**SUBJECT: NEW VEHICLE DEMONSTRATION / DELIVERY HOLD -  
Safety Recall 20S37**

Certain 2016-2018 Model Year MKX and 2019-2020 Model Year Nautilus Vehicles  
Equipped with 16-Way Power Front Seats - Wire Abrasion to Seat Frame

**FIGURE 2A**

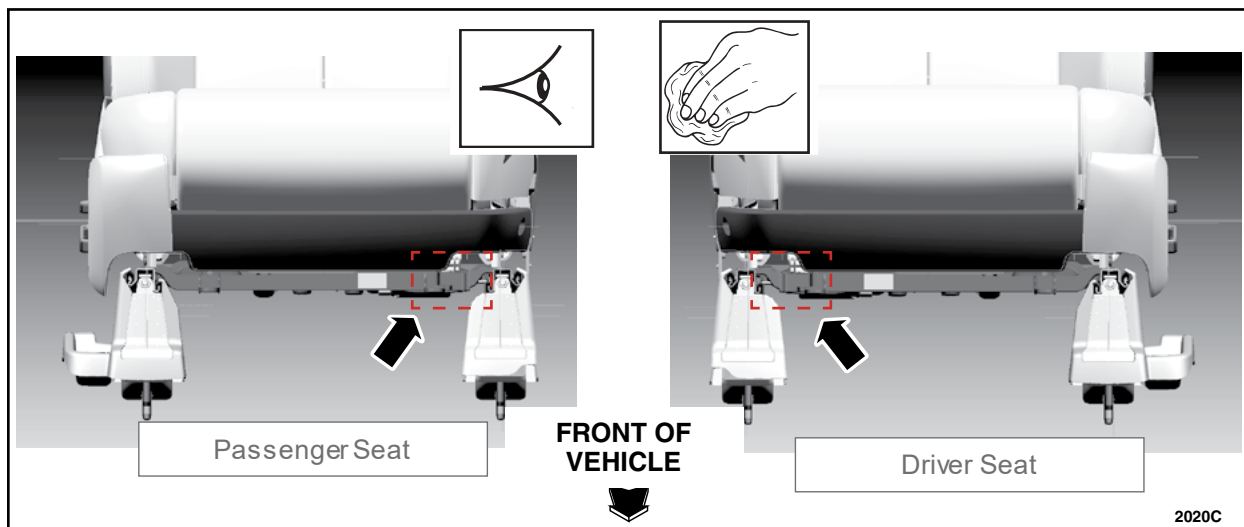
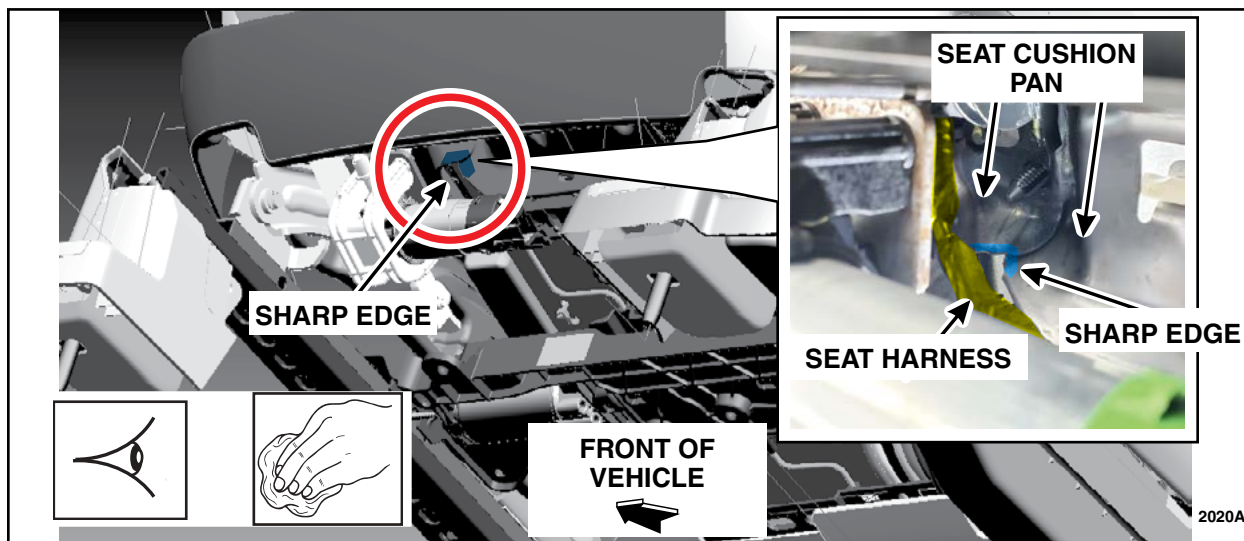
3. Locate and inspect the seat harness in the specified location. See Figure 2A and 2B.

4. Scuff the highlighted area of inboard side of the seat cushion frame using a Scotch-Brite® pad or equivalent then, using isopropyl alcohol and a clean shop towel, clean the highlighted area to remove any oil or residue. See Figure 2A and 2B.

**FIGURE 3**

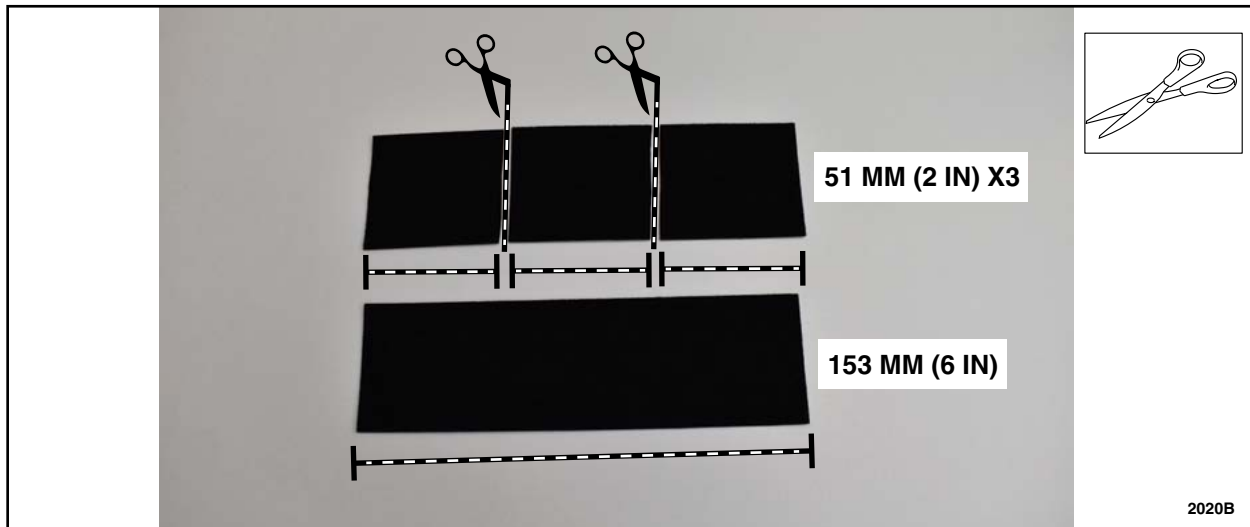
- If the squeak and rattle kit flocked tape is used, measure and cut three equal 51 mm (2 in) pieces. Only two of the three pieces will be used. See Figure 3.
- If the roll of flocked tape is used, measure and cut two 51 mm (2 in) pieces. The flocked tape roll is being used in safety recall 19S29 (2017 model year Explorer vehicles equipped with power seats - seat frame burred edge).

**FIGURE 4**

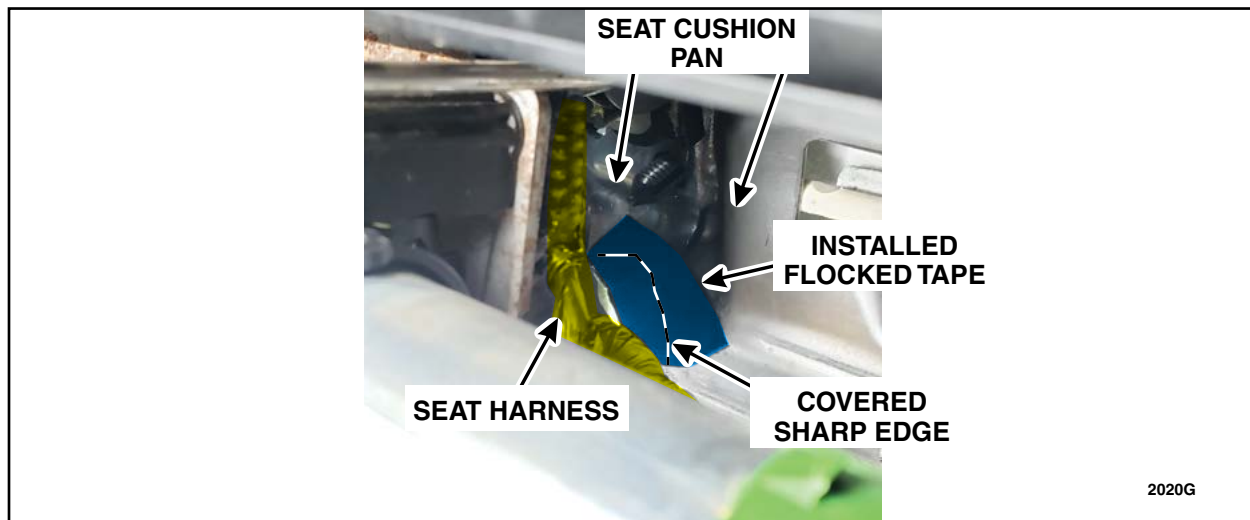
6. Peel off the backing from one 51 mm (2 in) piece of flocked tape and apply it to the highlighted area by wrapping it around the seat cushion frame to cover the sharp edge. See Figure 4.

**FIGURE 5**

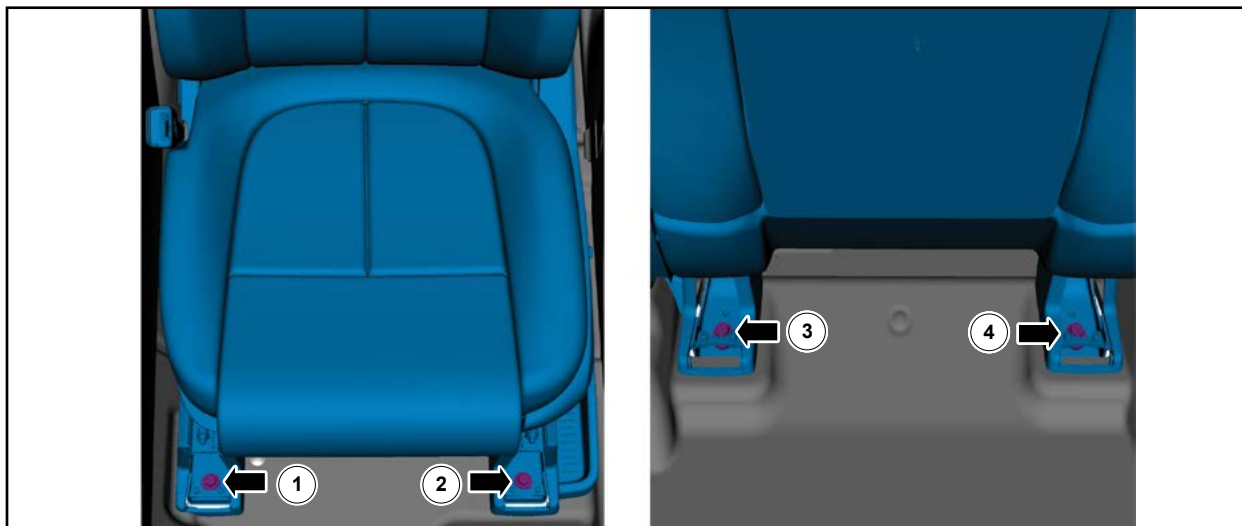
9. Tighten the seat bolts in the sequence shown. See Figure 5.

- Torque: 47 Nm (35 lb.ft)
